FINAL ENVIRONMENTAL IMPACT STATEMENT

It's Greener Now, Inc. – Padua Gravel Pit

Article 23, Mined Land Reclamation, DEC #8-4424-00006/00001 (MLR#80244)

Section IV: RESPONSE TO COMMENTS

DATE: 4/13/2018 | SCALE: 1"=125' | DWG. NO. 16157005A | PLATE 5 OF 9

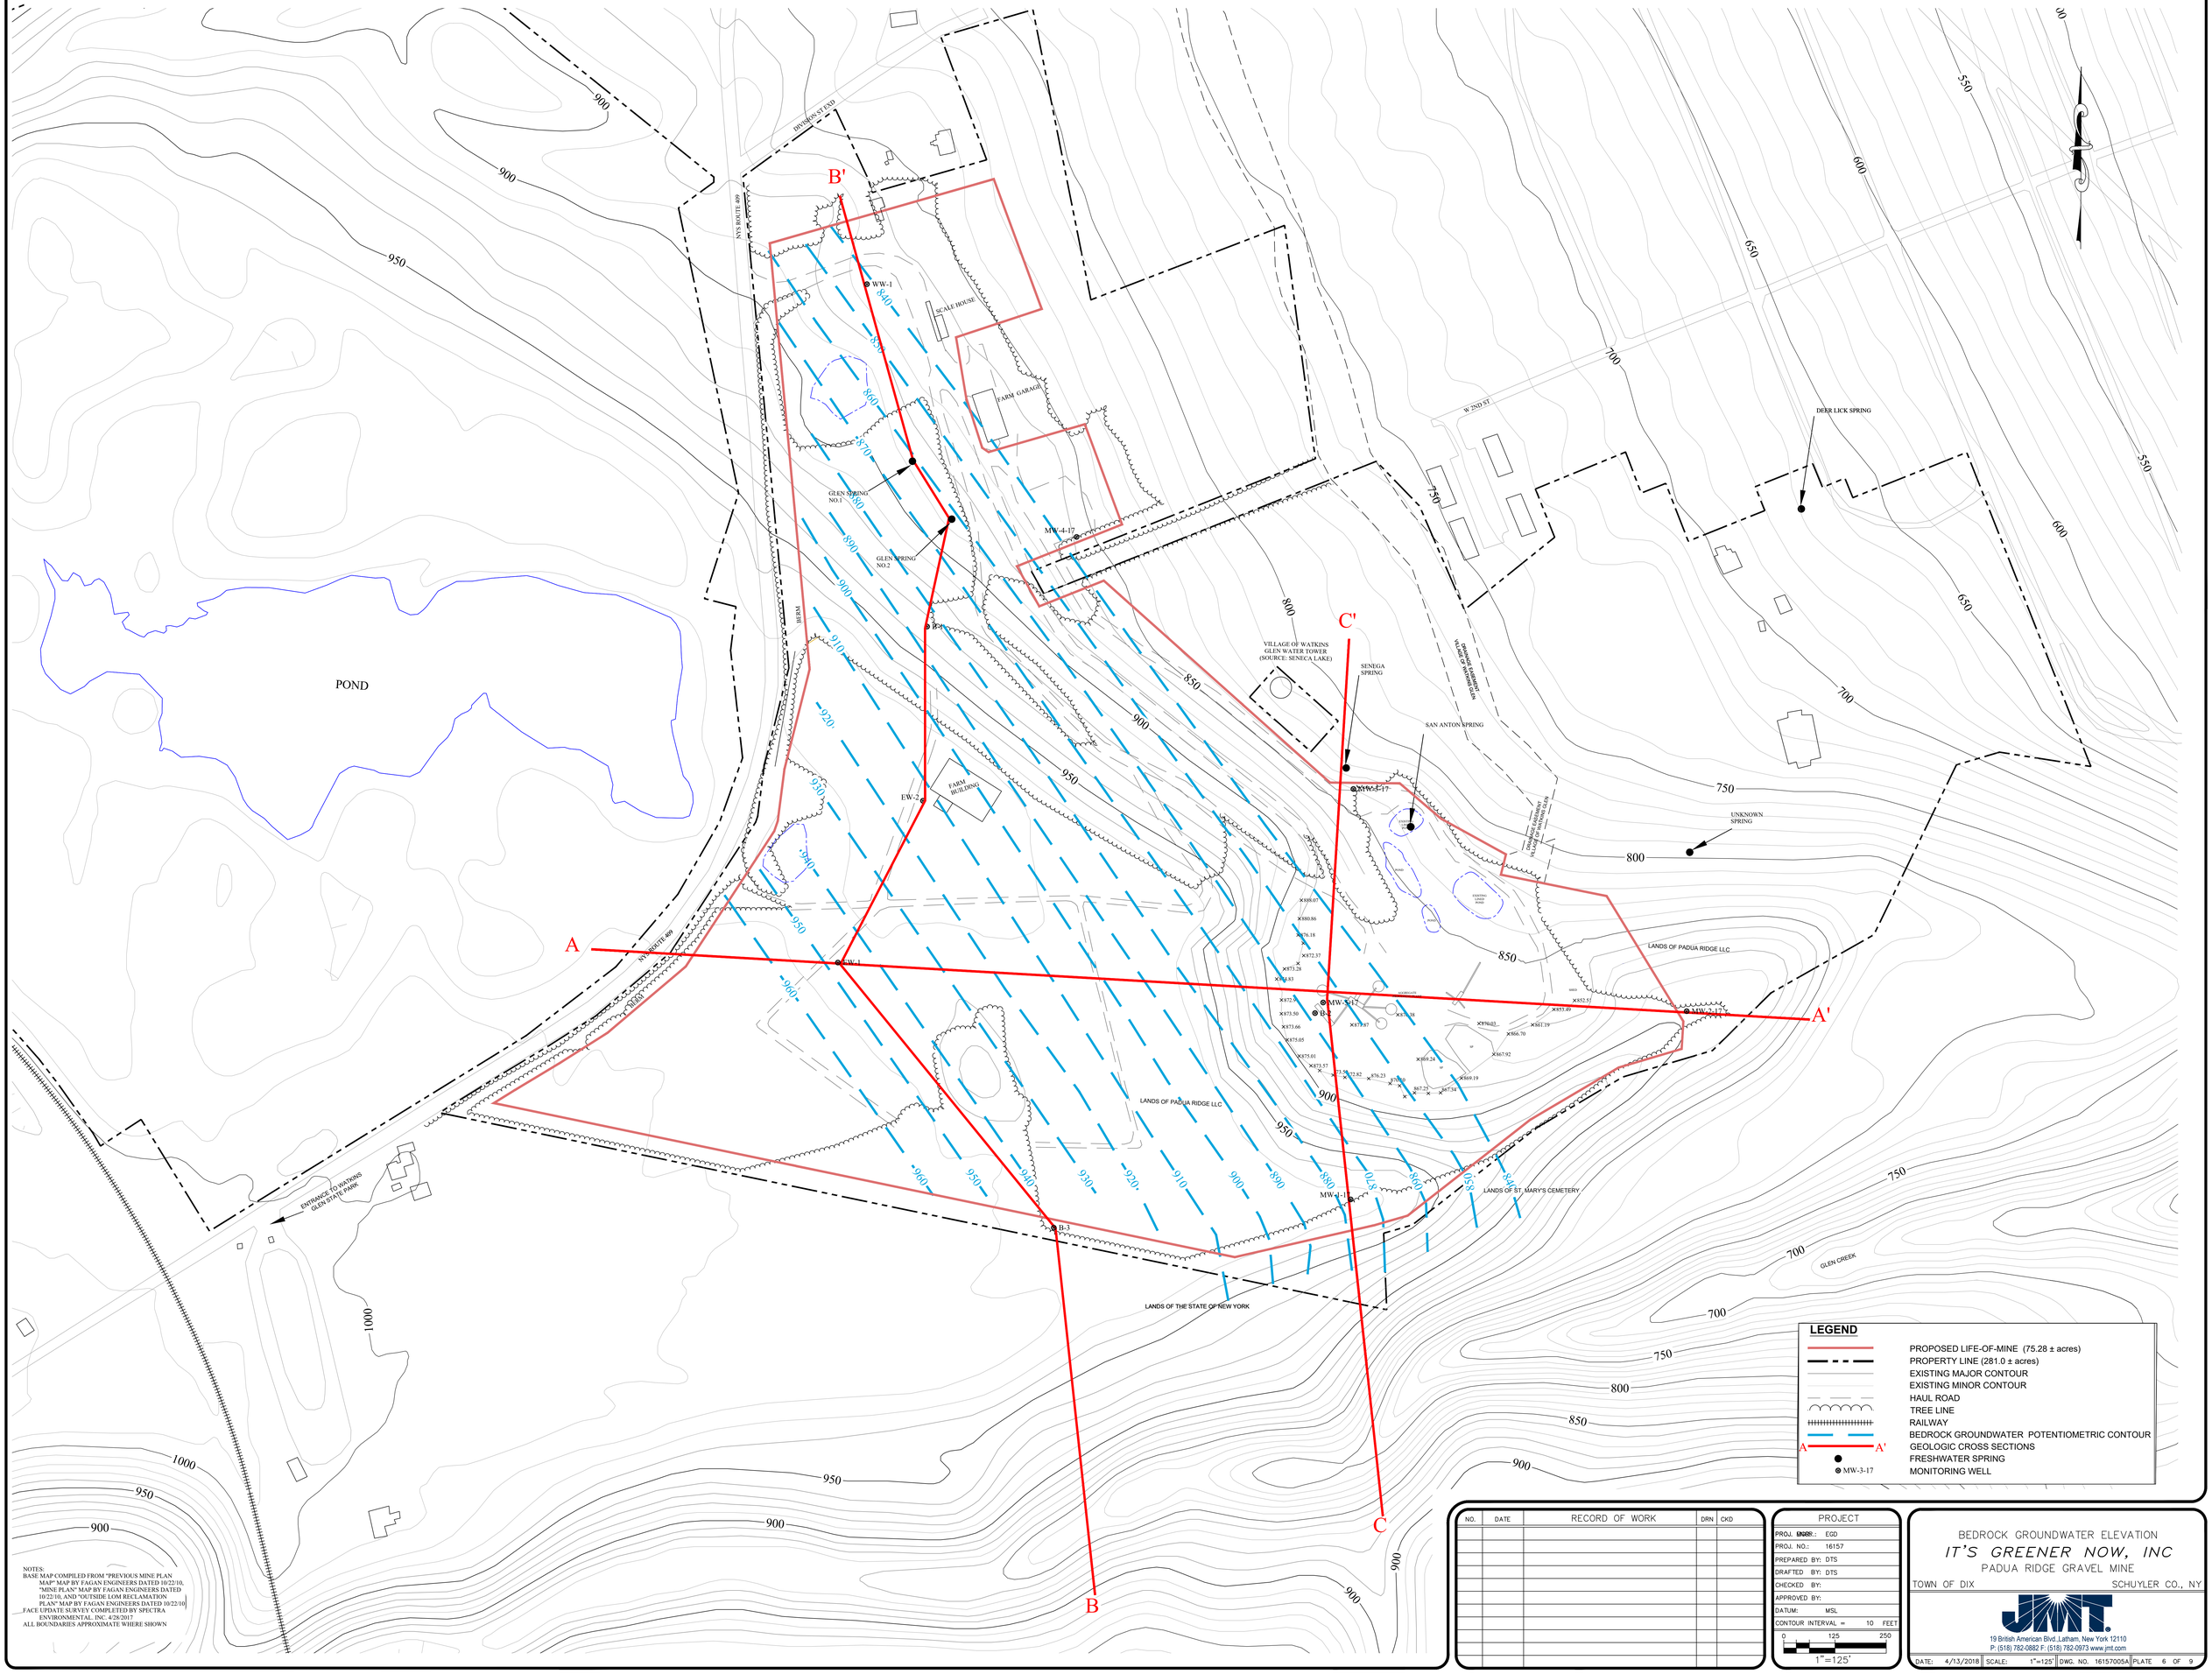
OPRHP Comment 18: *The overburden groundwater contour lines on Plate 5 should be dashed the same as the bedrock groundwater contour lines are on Plate 6, due to the very limited number of data points. Also, the lines should not extend beyond the IGN property line as a regional study was not completed as part of this DEIS and the groundwater contours are interpolated.*
